**PREVOST SAFETY RECALL CAMPAIGN SR12-29" AUTOMATIC FIRE DETECTION AND SUPPRESSION SYSTEM (AFSS) – PROTECTION OF LINEAR THERMAL DETECTOR (LTD)"**

Sr12-29

<b>DATE : SEPTEMBER 2012</b>	<b>SECTION : 23-ACCESSORIES</b>
<b>SUBJECT : AUTOMATIC FIRE DETECTION AND SUPPRESSION SYSTEM (AFSS) – PROTECTION OF LINEAR THERMAL DETECTOR (LTD)</b>

IR OPTICAL  
FIRE DETECTOR  
LOCATION

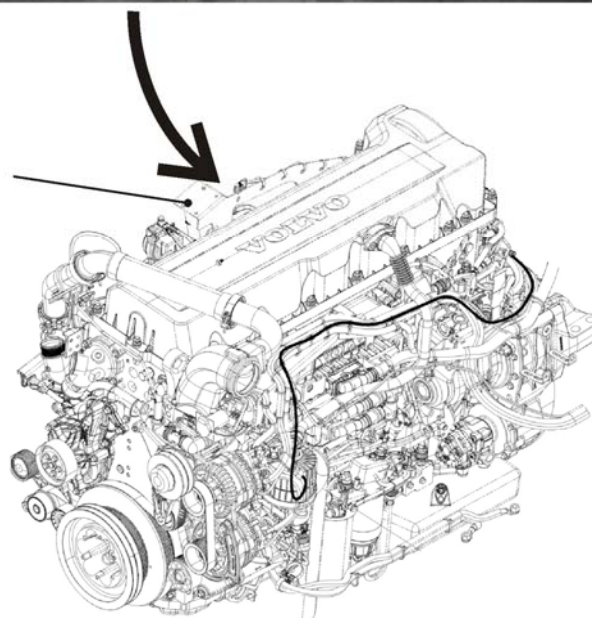
PROTECT LINEAR THERMAL DETECTOR SHEATH FROM RUBBING AT THIS LOCATION. CUT NYLON TIE AND ADD INSULATING FABRIC ADHESIVE TAPE. FIX WIRE WITH A NEW NYLON TIE.

1. There is only one location where the protective fabric tape might be too short or improperly located. Check the engine turbocompressor side near the optical infrared (IR) fire detector (see image above).

2. Cut and remove the existing nylon tie. Add enough fabric tape to protect LTD (red cable) from rubbing against the nylon tie. Fix LTD cable at the same location using included nylon tie.
